# FINAL MITIGATION PLAN

**Mockingbird Site  
Davie County, North Carolina**

**DMS Project #: 100021  
Contract #: 7185  
USACE Action ID #: SAW-2017-01505  
DWR Project #: 20171040  
RFP #: 16-006993**

Re: NCIRT Review and USACE Approval of the Mockingbird Site Mitigation Plan; SAW-2017-01505;  
NCDMS Project # 100021

**Figure 8c - Existing Conditions Map (South)**  
**Mockingbird Mitigation Site**  
 Davie County, North Carolina

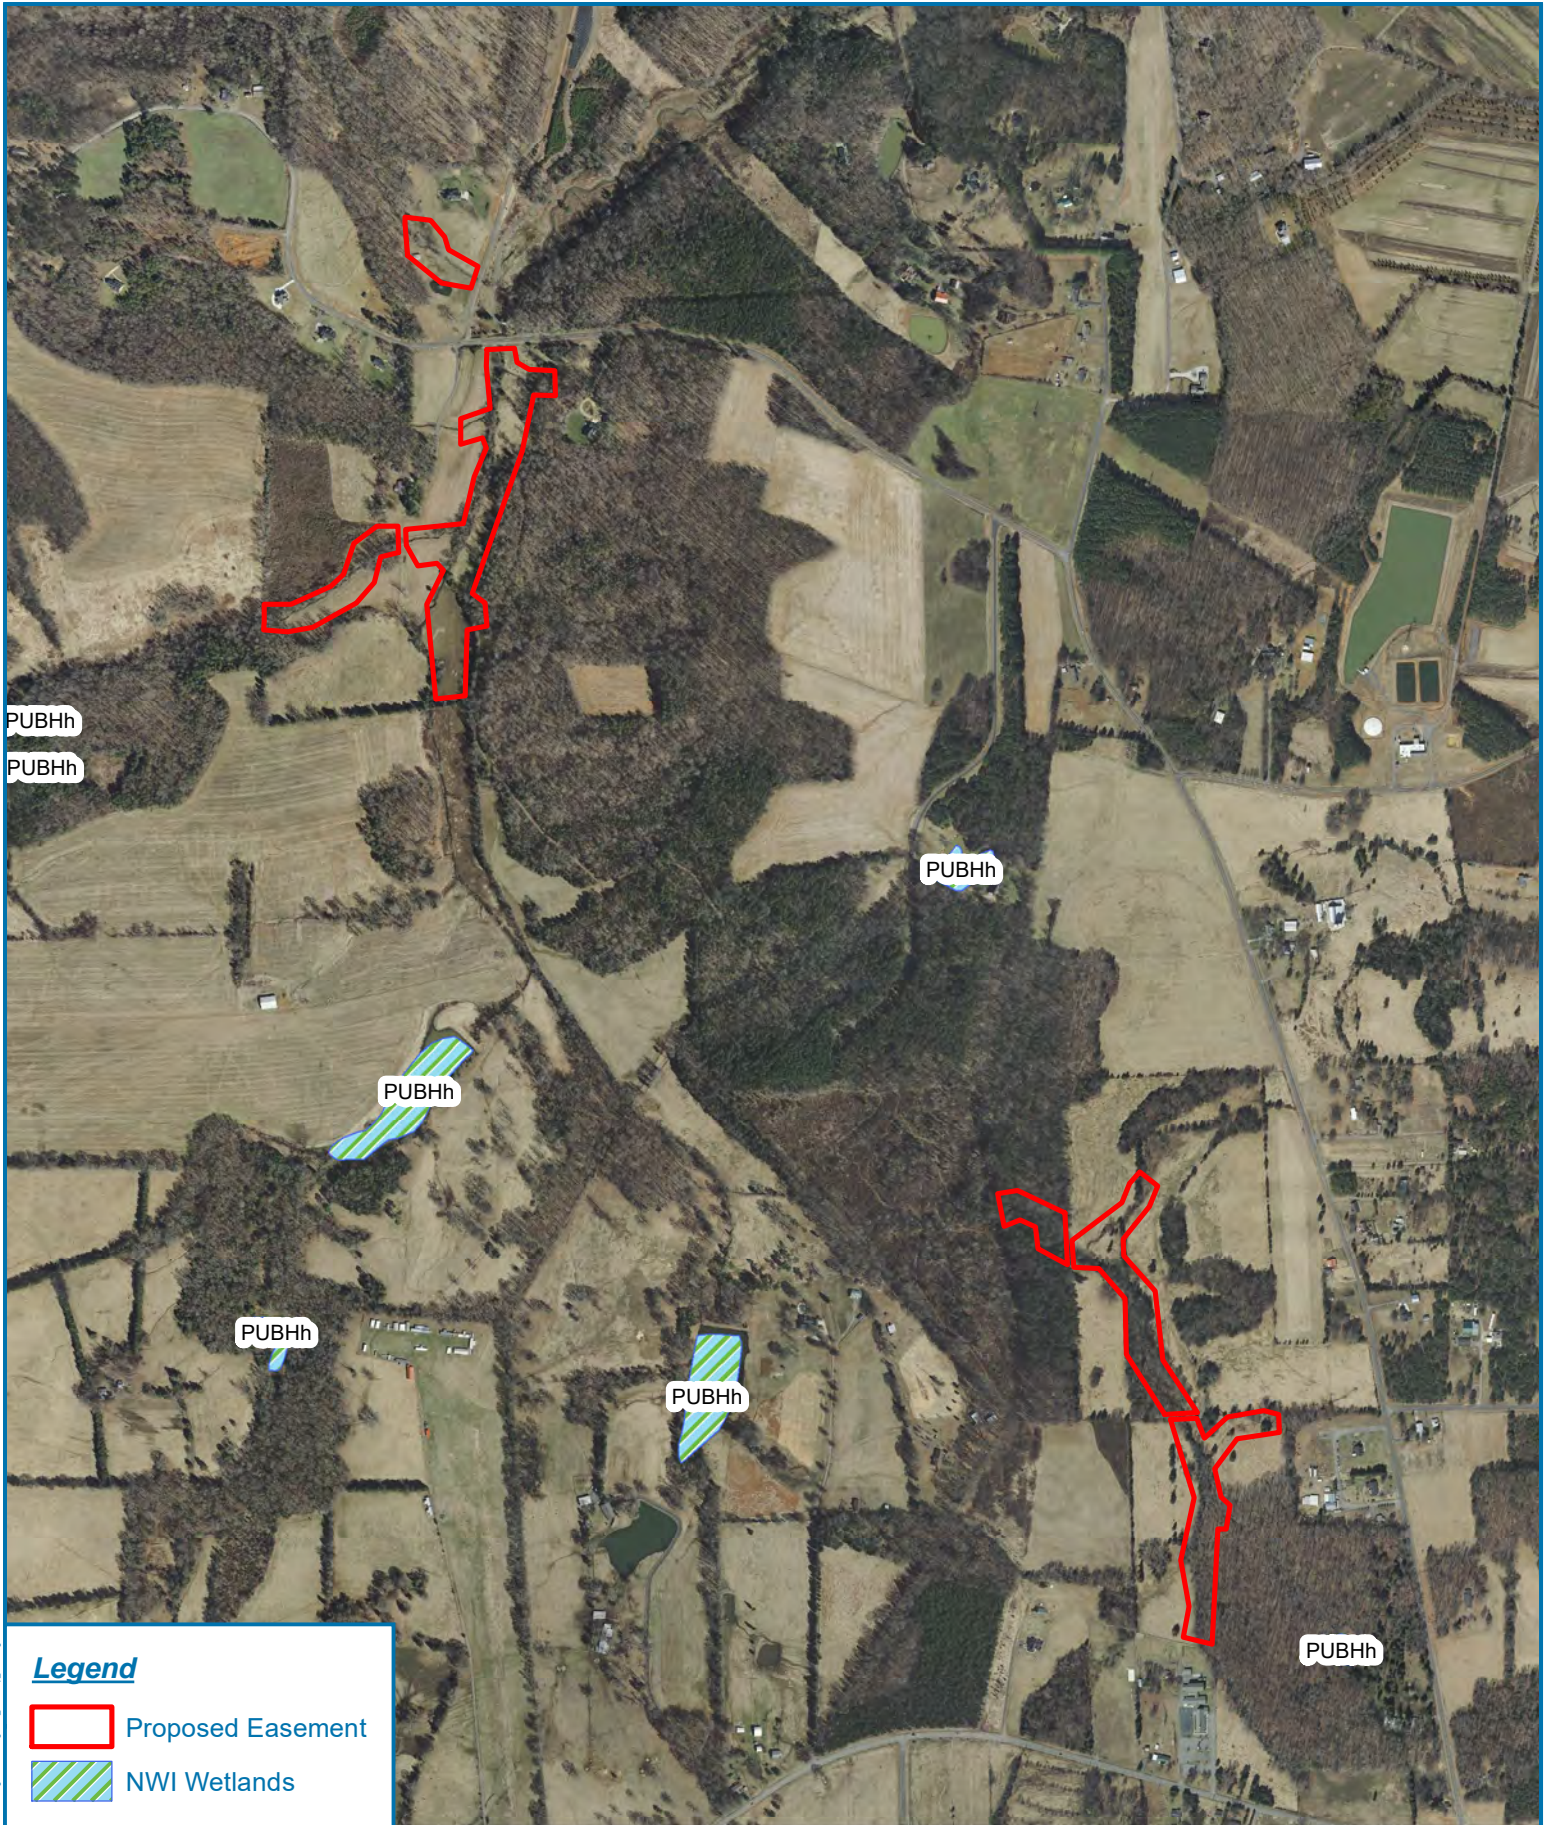
2. DWR needs to see consistency in the labeling of reaches. On Figure 8c reach HC2-C is labeled in one location and on Figure 10b is labeled in another location. This is confusing when reading the existing channel morphology summaries and not knowing which reach is being described. For example, what I was looking for was a description that included existing wetlands in reach HC2-B and HC2-C, but did not see any mention of existing wetlands. Initially I was focusing on reach HC2-B, and that when I became confused with the labeling.  
Figure 8c (existing conditions) has been updated to better show which reach is being labeled. Also, wetland acreage has been added to the appropriate reaches in the existing conditions section (Reaches HC2-A, HC2-B, TP2 and TP3).

3. Figure 8C—The wetland maps indicate there are potential jurisdictional wetlands at the top of reach TP3 where a BMP is planned. BMPs will need to be placed outside of jurisdictional waters. Additionally, since the dry detention basin areas are located within the stream buffers, the mitigation plan should include a performance standard for the marsh areas tied to vegetation success.

The BMP on Reach TP3 has been revised to a sediment trap which incorporates woody debris and live stakes and should not impact the potential wetland areas. This is not a permanent structure that is being placed in the jurisdictional wetland and is all wood. Also, the treatment on TP3 is enhancement II, so this will not increase or affect the wetland hydrology on Wetland A. Wetland A is mostly outside the easement area (0.26 acres in easement vs. 0.83 acres in total for WA). Since the dry detention basin has been revised to the sediment trap and the treatment is enhancement II, there are not any additional performance standards for this “marsh area”. All planted areas will be monitored for success and we have moved the vegetation plot upstream on TP3 to be in/near the wetland area.

MB5

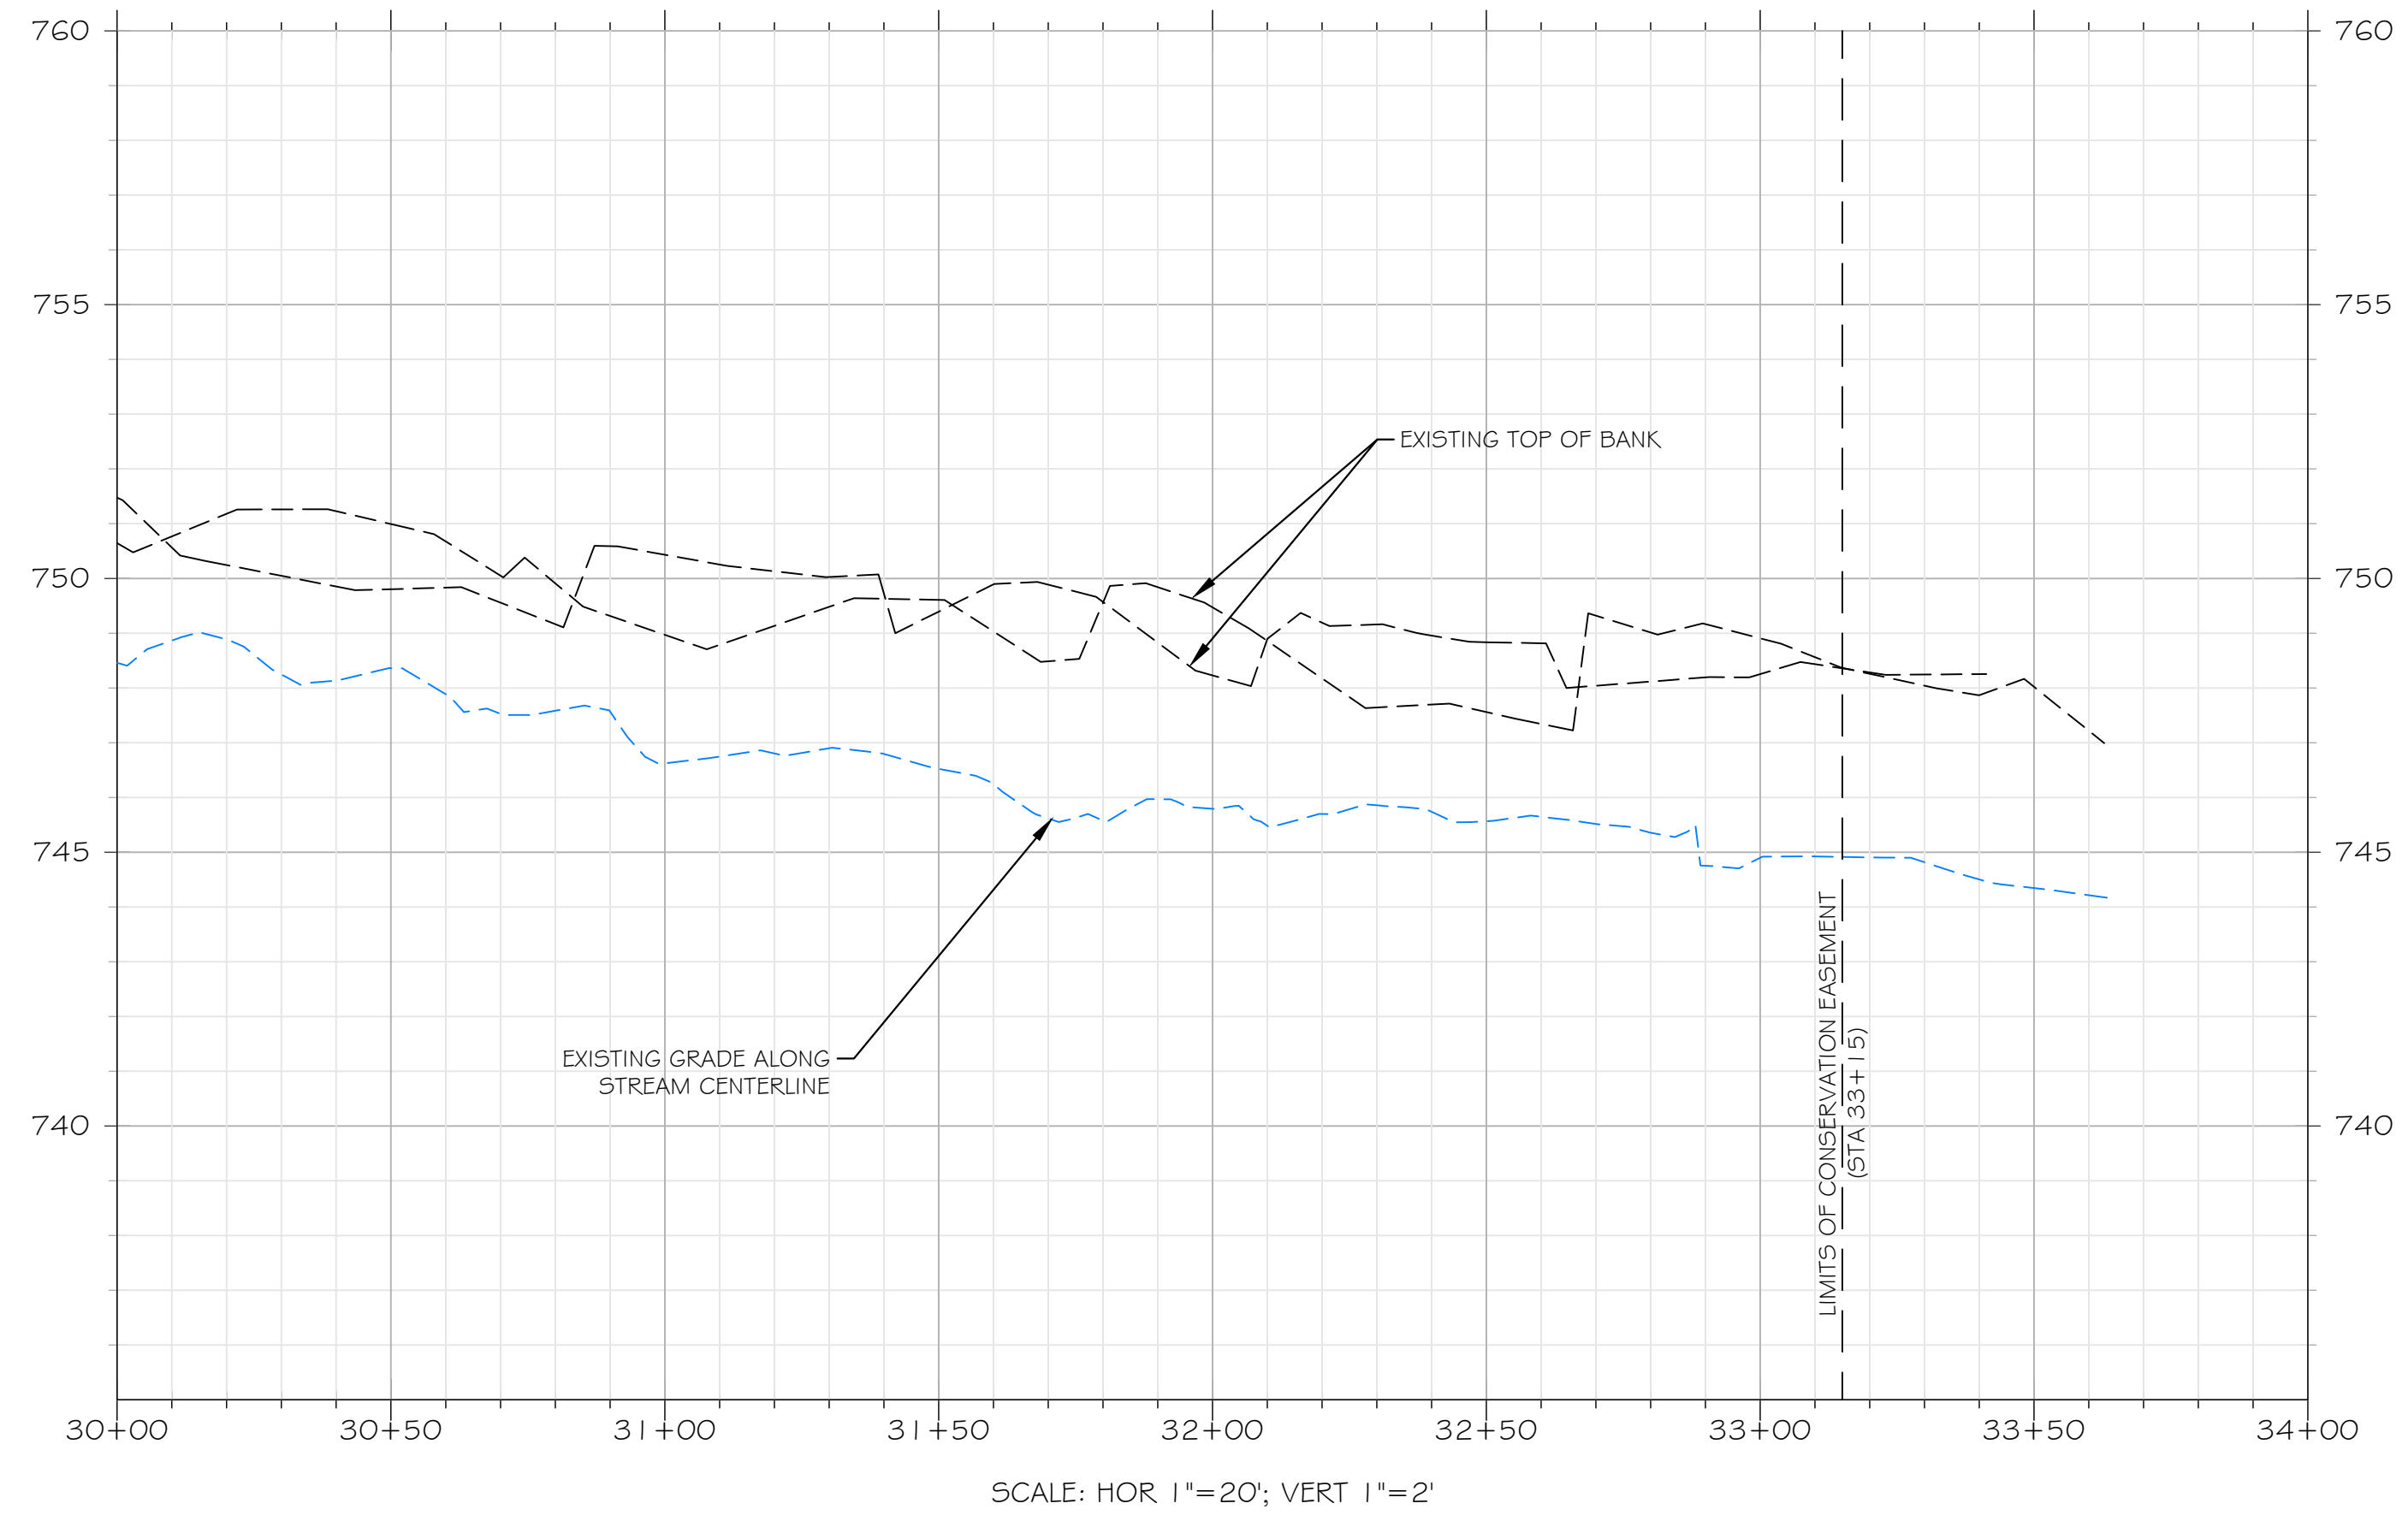
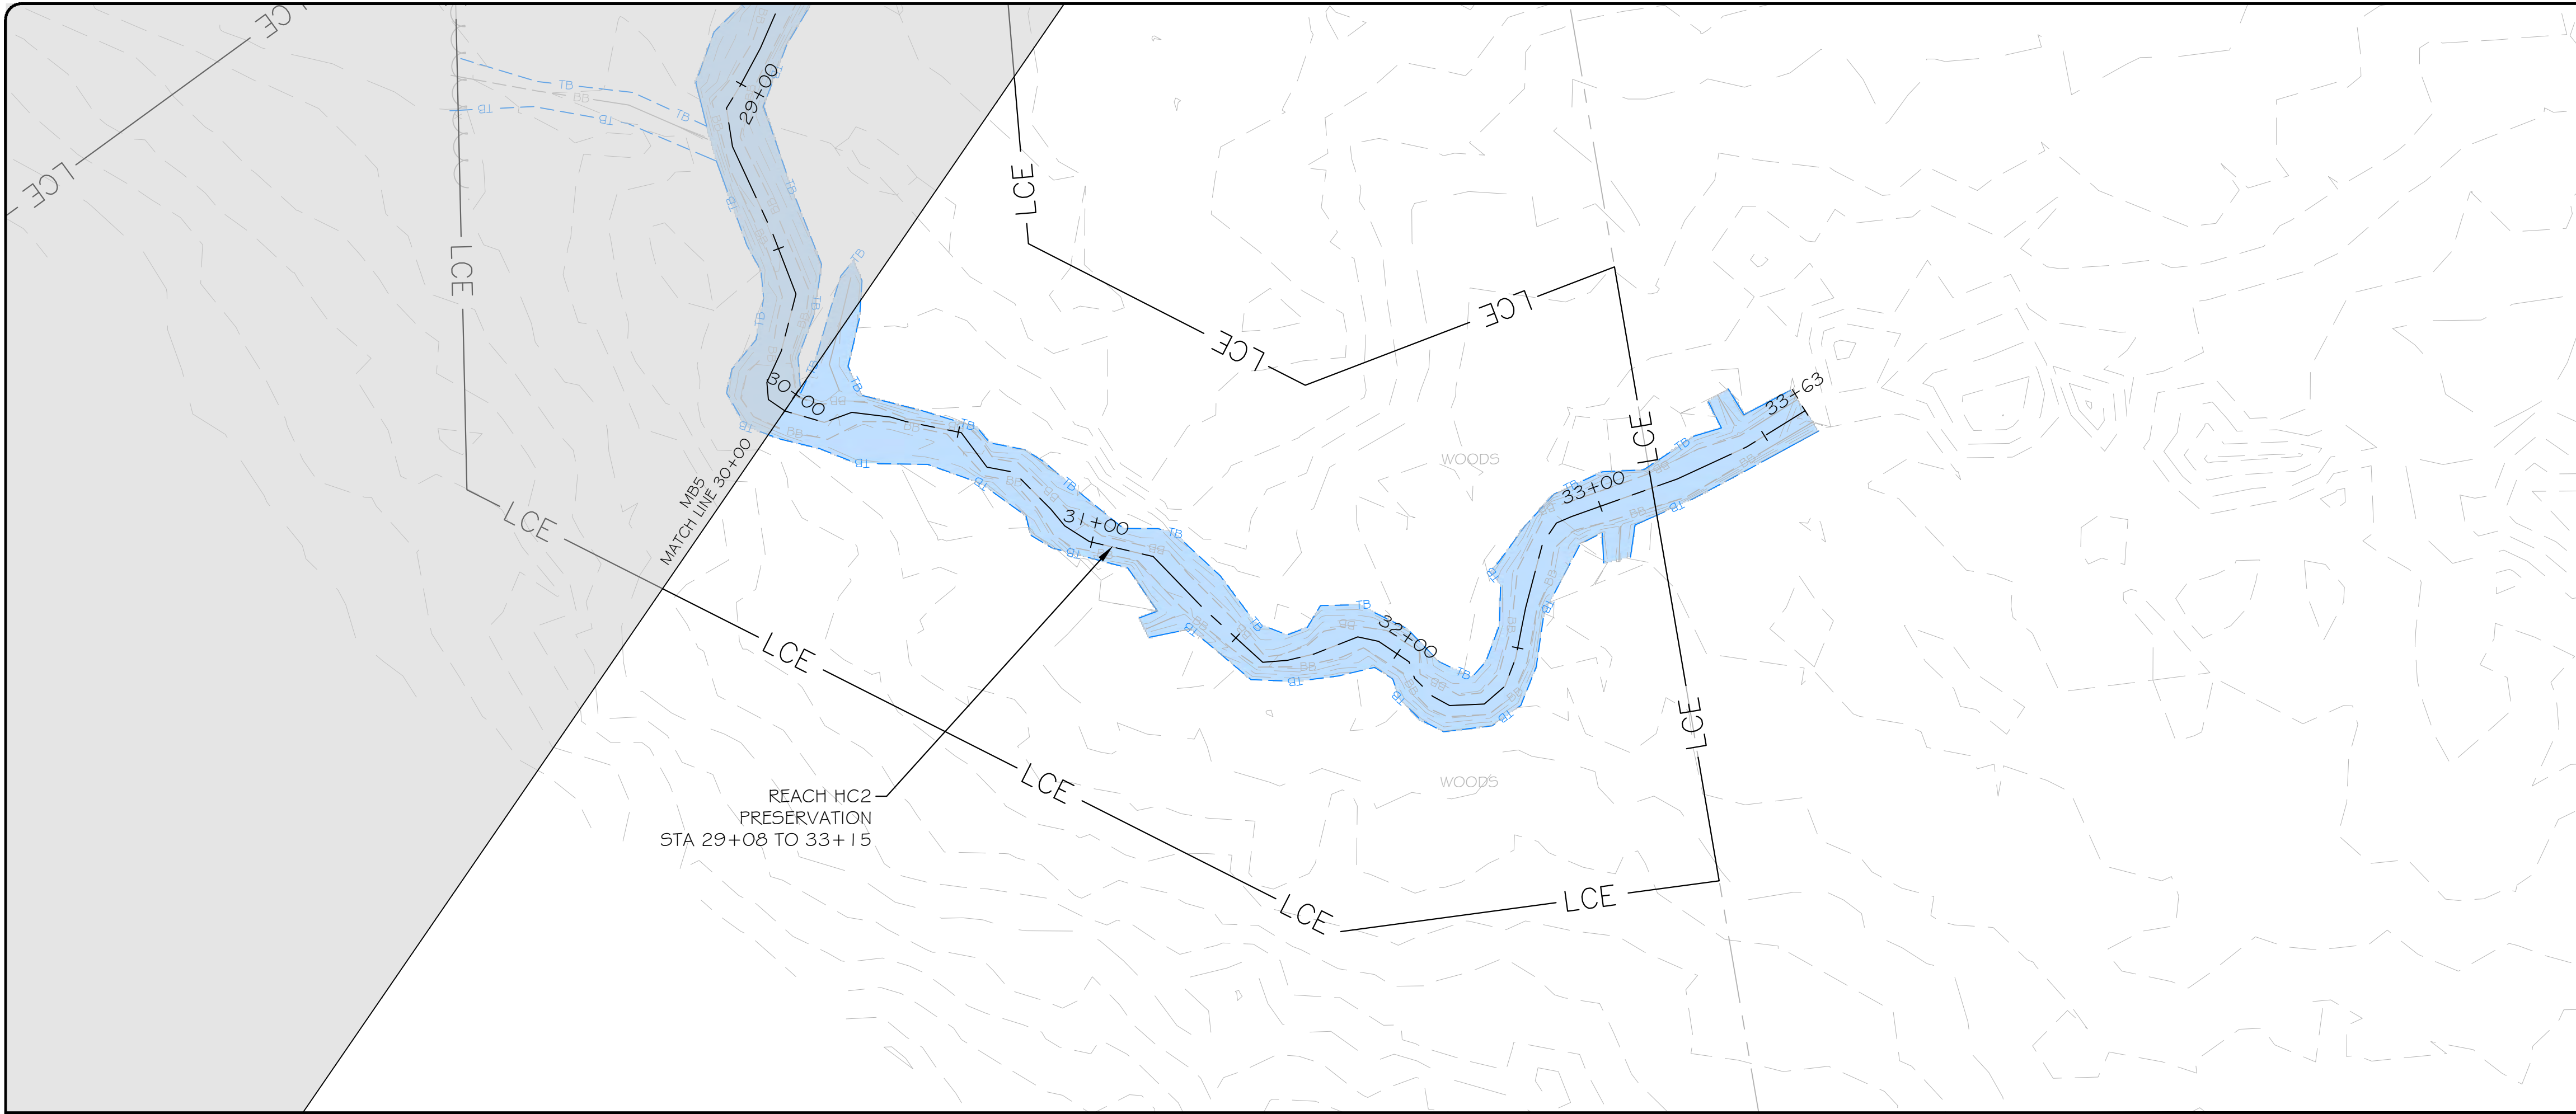
7. DWR notes that the typical for channel backfill referred to on Design sheet MB5 is actually on sheet D2 and not sheet D3.  
Callout has been adjusted on sheets MB4 and MB5 to reflect correct detail sheet. Callout has also been added to other applicable sheets where backfill/abandonment occurs.
